ADA Curb Ramp New Construction Inspection Form (Perpendicular)

Nw 292nd

23885.56

Nw fair

PERPENDICULAR RAMP (PR)

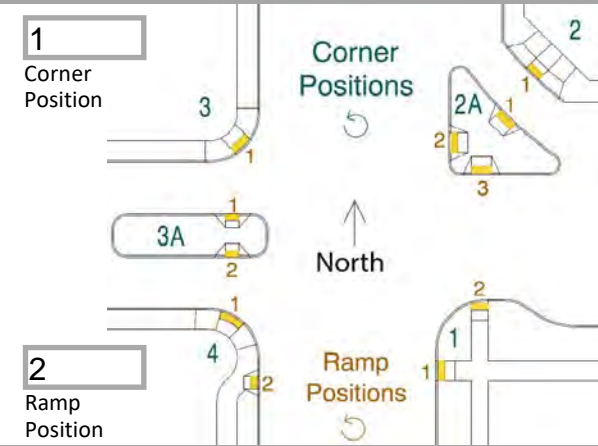
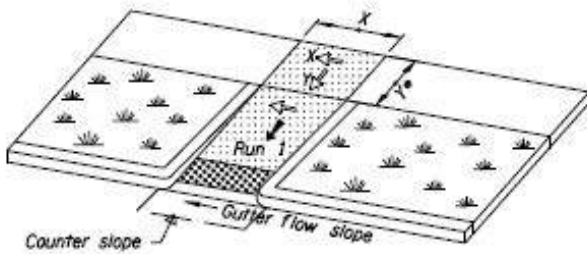
Slope X

2.7

☒

Tool joints in TS
